Access Compliance Report

Public Rights-of-Way

(Curb Ramps)

Intersection ID: 32112	Main Street: ADISON_GRAY_LN	Cross Street: COUNTRY_LN	Location: SE
ADA ID: 056DBD83B07F	Ramp Type: BlendTrans1	Initial Pass/Fail: Fail	Overall Compliance: No
			Severity Score: 33.75

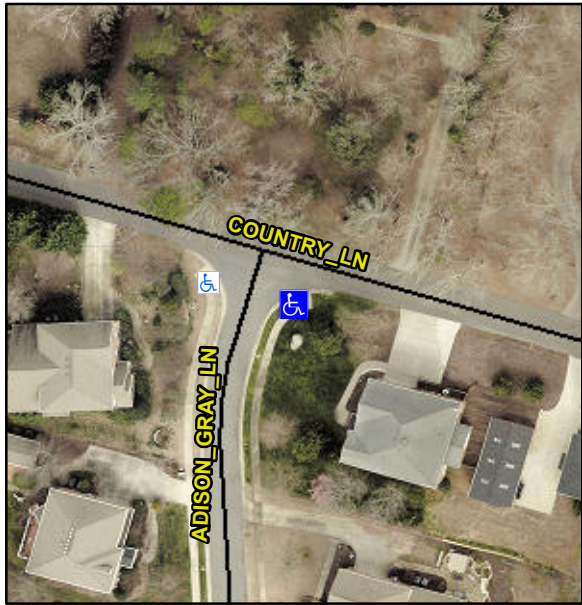
N/A	Landing Curb? (Y/N)	N/A	N/A	DWS Offset (in)	N/A
			N/A	Shared Landing?	N/A			
			N/A	Gutter Ponding?	N/A	N/A	Gutter Slope (%)	N/A
			N/A	Gutter Lip Ht (in)	N/A	N/A	Gutter X Slope (%)	N/A
			N/A	Painted X Walk1?	No	N/A	Painted X Walk2?	N/A
				X Walk 1 Direction	To W		X Walk 2 Direction	N/A
				X Walk 1 Width (in)	N/A		X Walk 2 Width (in)	N/A
				X Walk 1 Slope (%)	7.9		X Walk 2 Slope (%)	N/A
				X Walk 1 X Slope (%)	9.8		X Walk 2 X Slope (%)	N/A
		N/A	Ramp inside XWalk1?	N/A	N/A	Ramp inside XWalk2?	N/A	
			Road Slope (%)	9.8		Clear Space?	N/A	
			Road X Slope (%)	7.9	N/A	Clear Space to XWalk (in)	N/A	
		N/A	Any Obstructions?	N/A	N/A	Storm Grate/Utility Hazard?	N/A	
			Obstruction Type			Storm Grate/Utility Type		
					N/A		N/A	
					Yes	Surface Condition? (G/P)	Good	
					No	Curb Slope (%)	7.8	
Surveyor Notes:								
N/A								
PROW/ADA:								
Not Found, R304.5.1, R304.5.3								
Total Cost:		\$	3200.00
